Decision Notice - approval (with conditions)
Given under section 63 of the *Planning Act 2016*

Application number:	DA/4426
Approval sought:	Development Permit for a Reconfiguration of a Lot

Description of the development proposed:	Reconfiguring a Lot - Four (4) Lots and Common Property into Four (4) Lots and Access and Services Easement

Street address:	23 - 26 Webber Esplanade COOKTOWN 4895
Real property description:	Lot 0 on SP188678 Lot 1 on SP188678 Lot 2 on SP188678 Lot 3 on SP188678 Lot 4 on SP188678

PLAN OF DEVELOPMENT

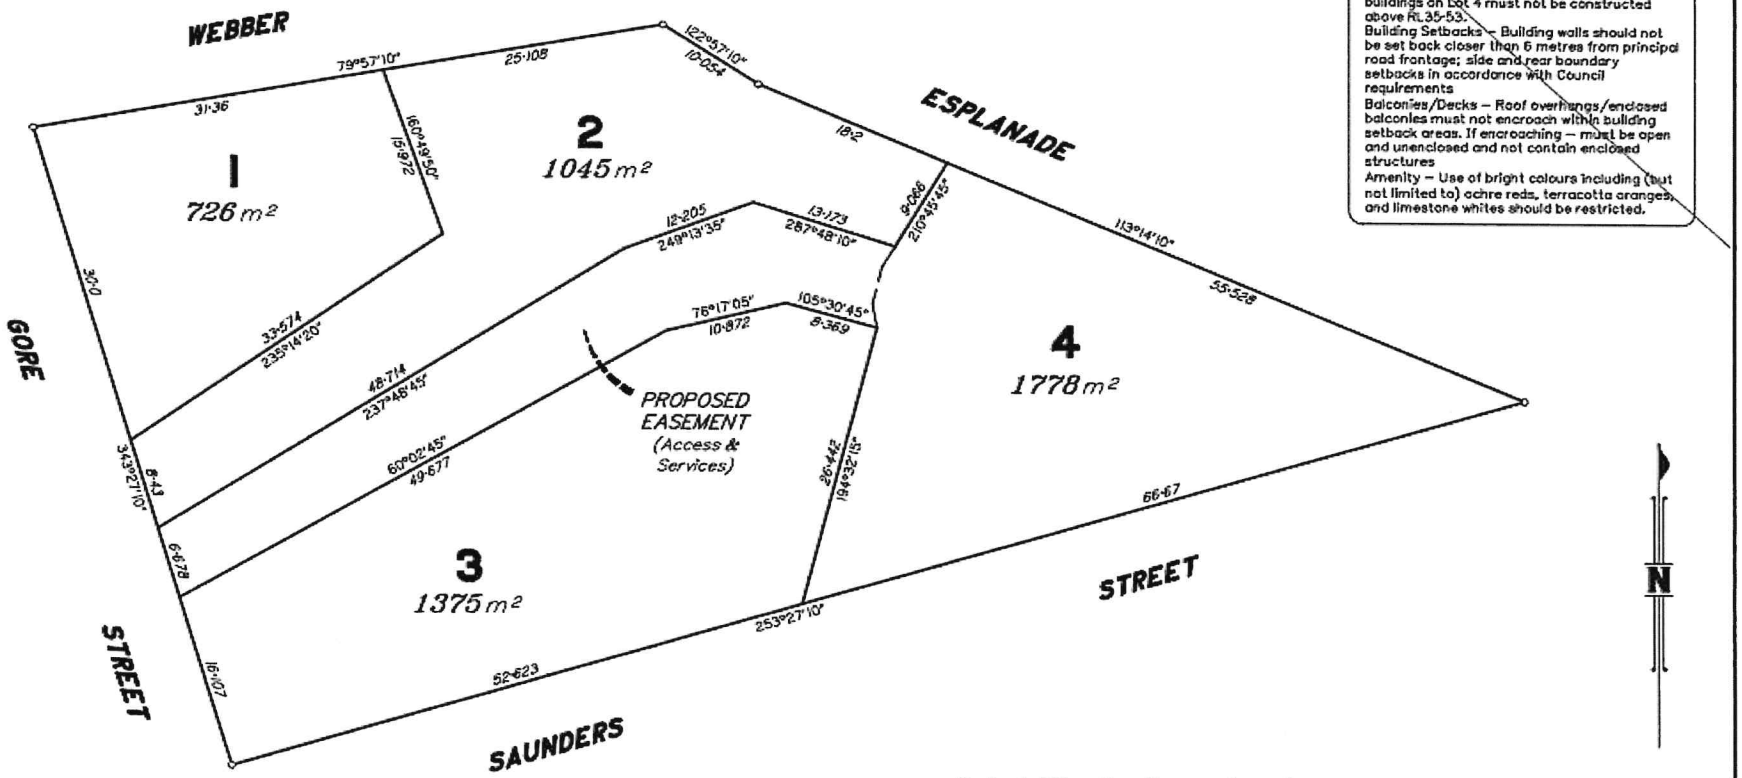
2. The proposed lot layout must be amended to ensure all services and retaining wall structures are wholly contained within the proposed lot boundaries as follows:

(a) amendment to the boundary of proposed Lot 1 in the south-eastern corner to ensure the retaining wall is wholly contained within proposed Lot 2;

(b) amendment to the boundary of proposed Lot 3 to ensure the retaining wall in the access handle of proposed Lot 4 is wholly contained within proposed Lot 3;

(c) amendment to the boundary of proposed Lot 3 to ensure existing stormwater infrastructure is wholly contained within proposed Lot 3; and

(d) amendment to the boundary of proposed Lot 4 to ensure the retaining wall is wholly contained within proposed Lot 3.

3. The Development Controls identified on the approved plan of development (Murray & Associates, Drawing No. 7967-23343, dated 10/08/2021) do not form part of this approval.
